APPROVED
Limited building only review.
Permit holder responsible for full compliance with the code.

THE BRADFORD
LEFT HAND GARAGE
HUNTER'S DREAM HOMES

DATE:
03/18/24

SECOND FLOOR PLAN
SCALE 1/4" = 1'-0"

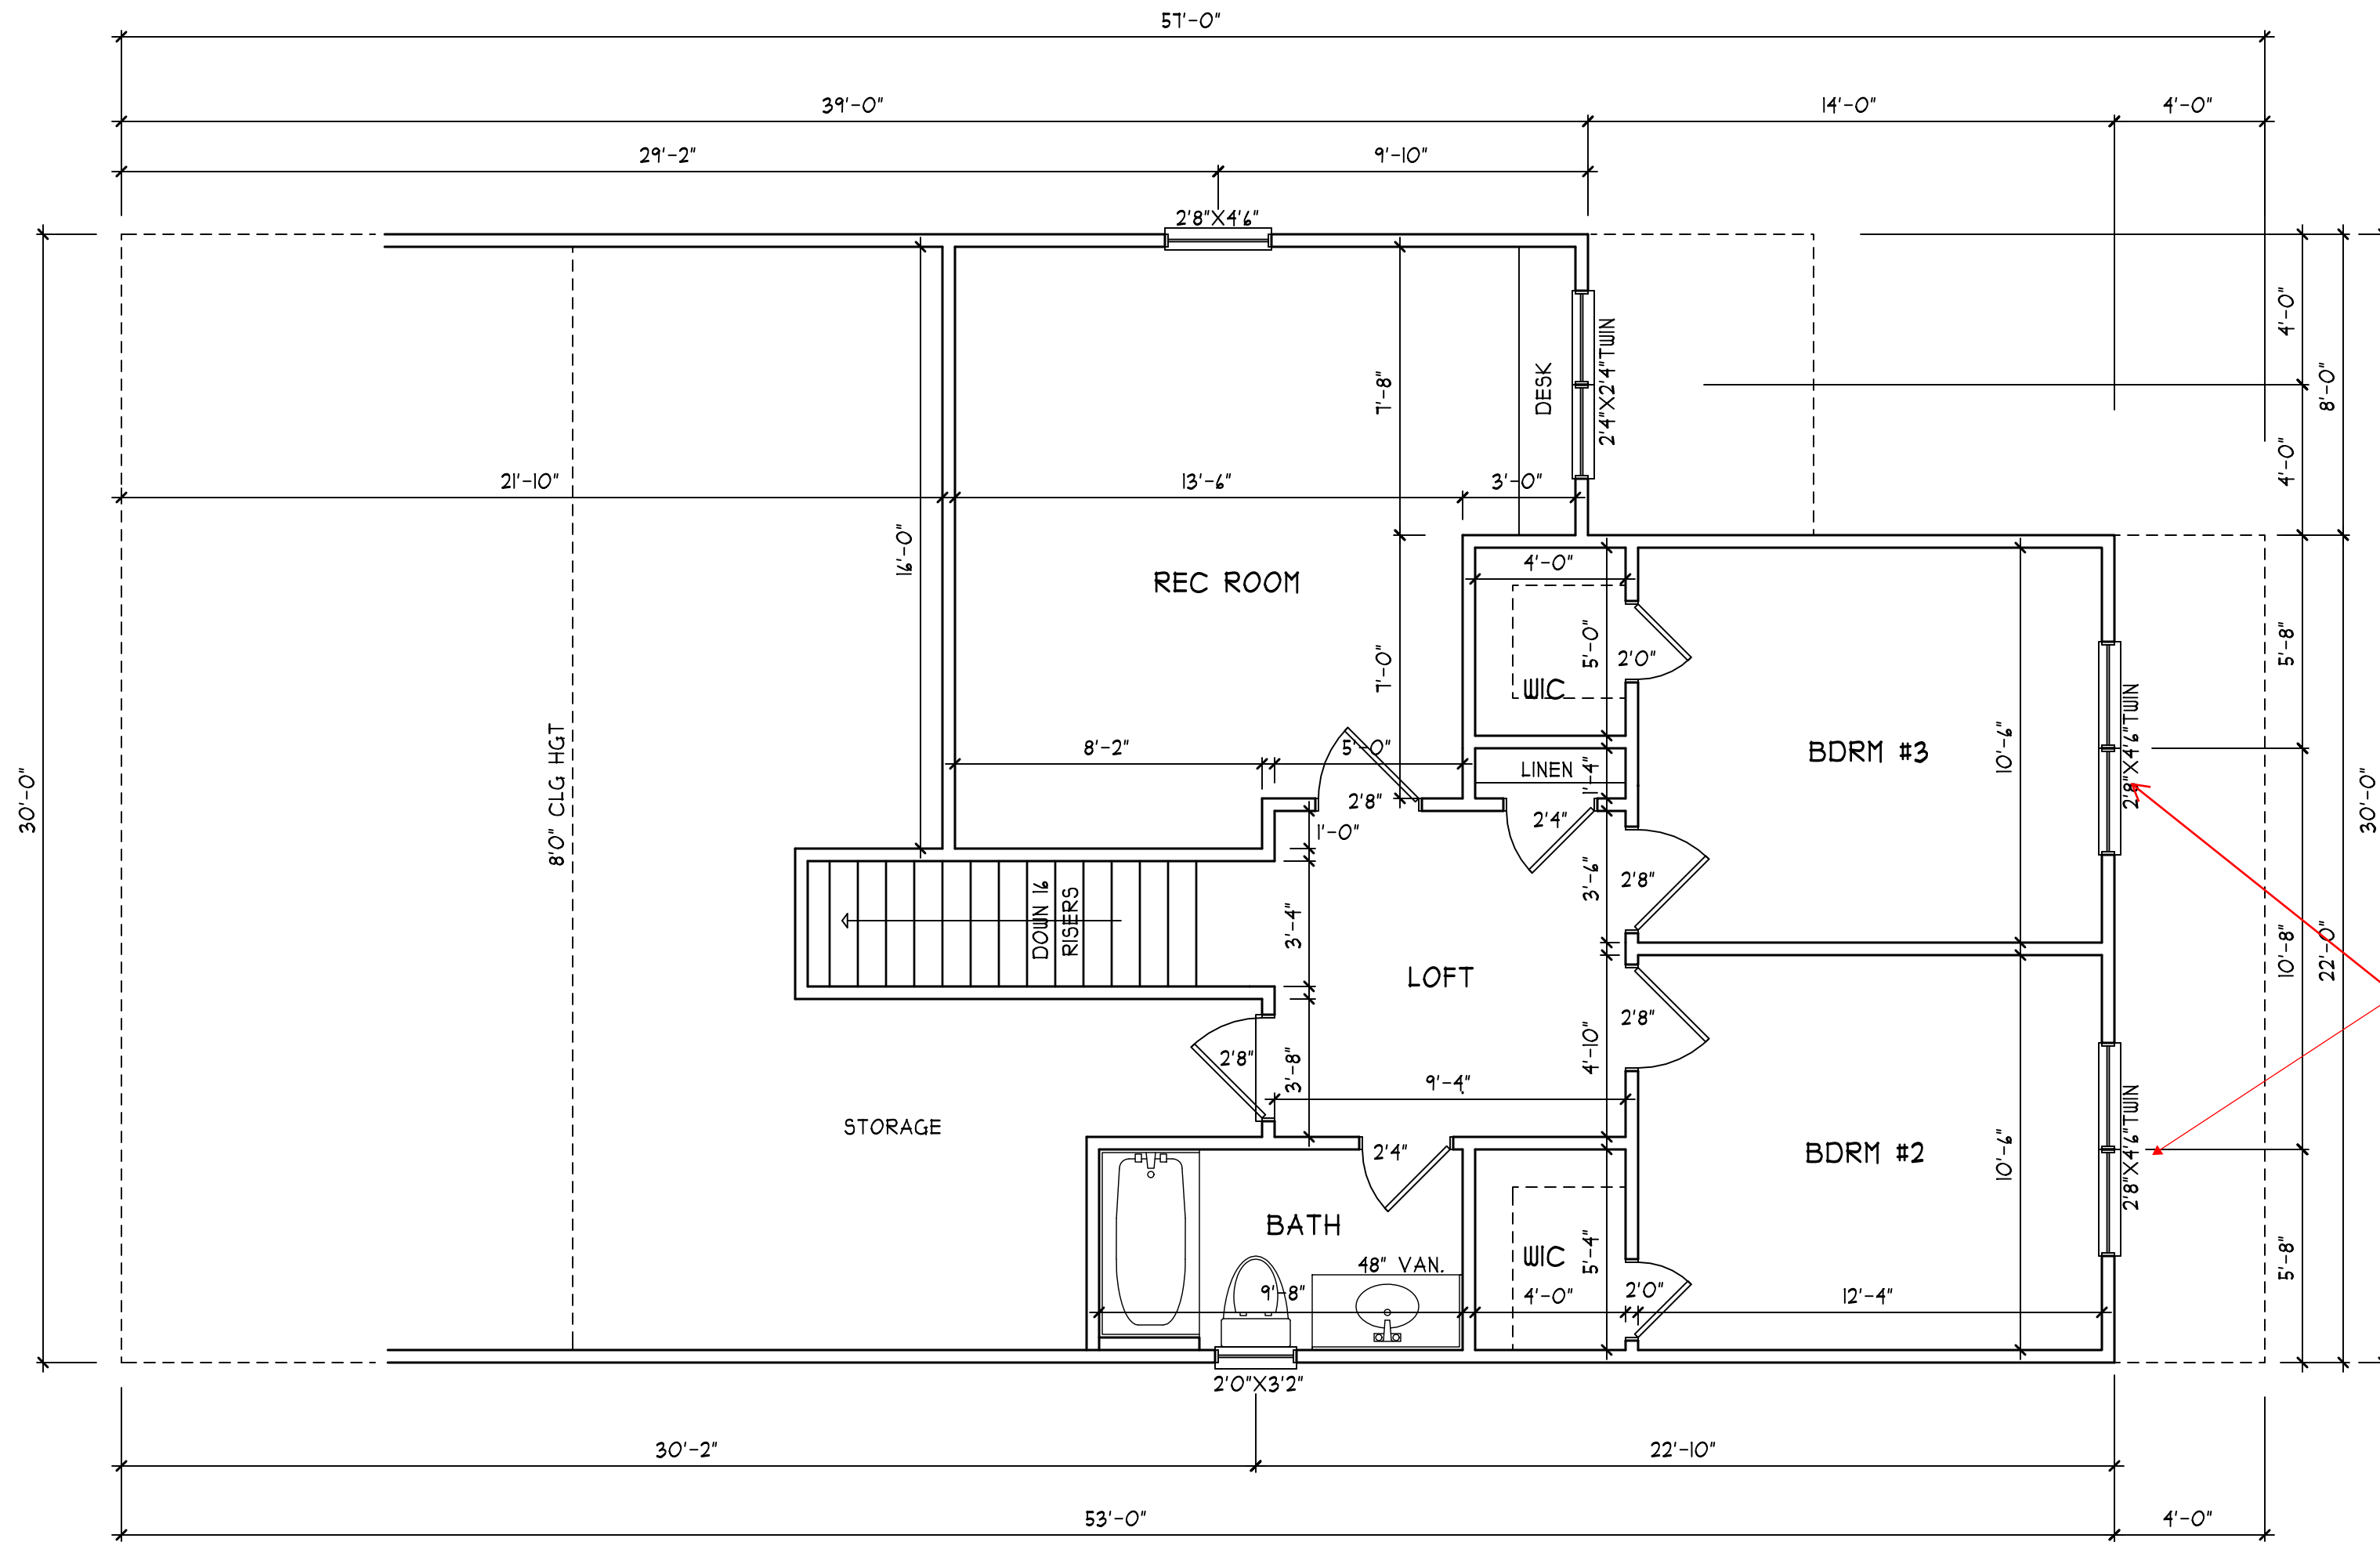
Verify Egress
